CERTIFICATE OF APPROPRIATENESS

Applicant: Phil Arnett for 2315 Union Street, LLC, owner

Property: 2315 Union Street, Lot 11, Block 384, Baker W R NSBB Subdivision. The property includes a historic 900 square foot, one-story wood frame single-family residence situated on a 5,000 square foot (50' x 100') interior lot.

Proposal: Alteration –

NORTH ELEVATION – FRONT FACING UNION STREET

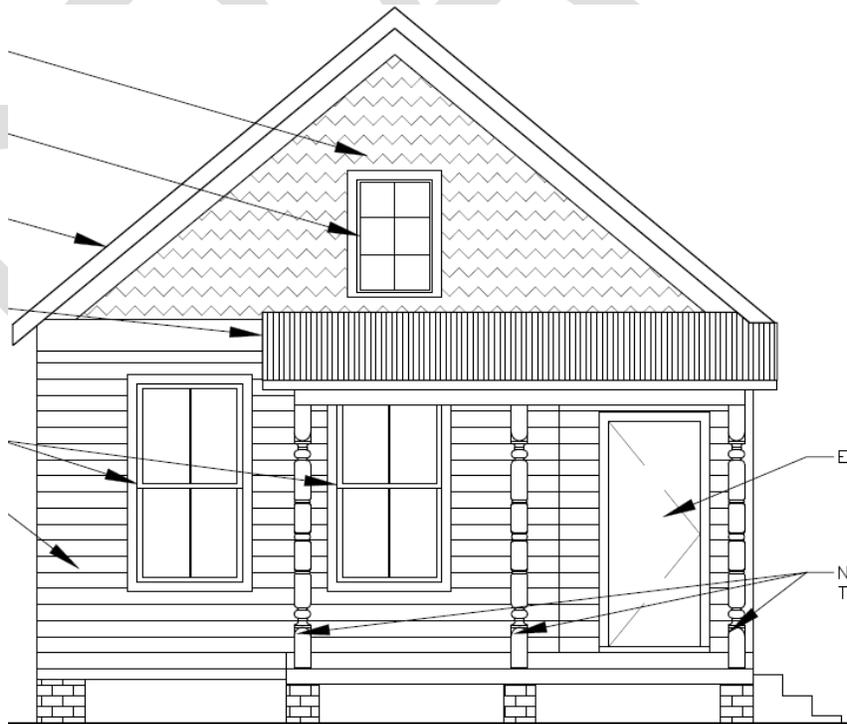
- Replace nine non-original aluminum windows with wood 2-over-2 sash windows; the window openings will not be modified
- Replace three non-original square porch columns with three wood turned columns that match the original existing turned porch column.

Recommendation: Approval

EAST SIDE ELEVATION

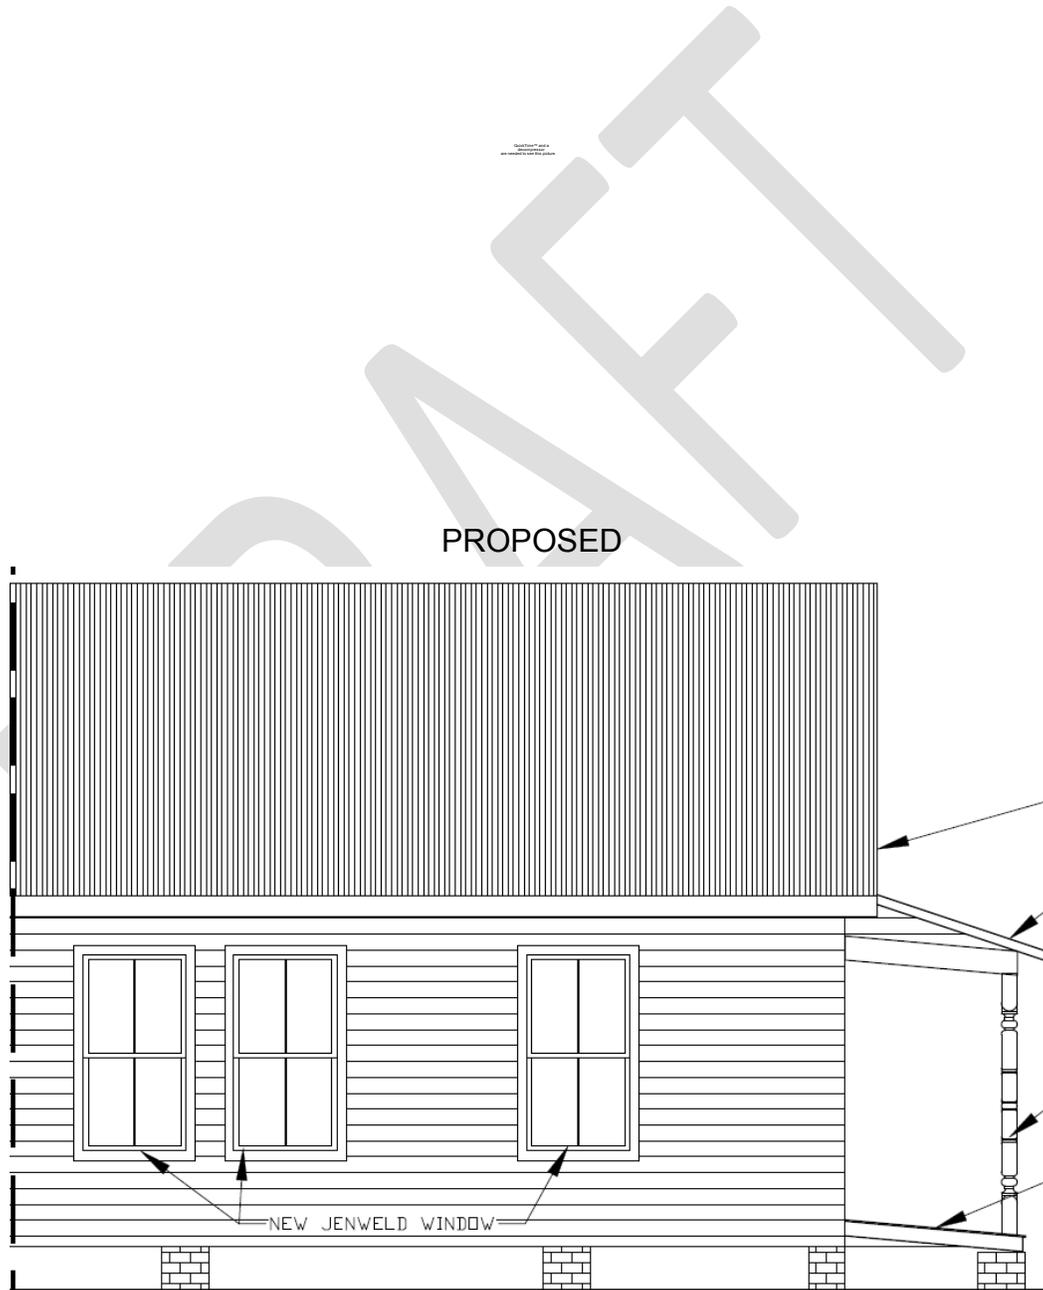
Windows/Doors: The residence features non-original 6-lite and 4-lite aluminum windows. The windows on the north, east, and west elevations will be replaced with wood 2-over-2 sash windows; the window openings will not be modified.
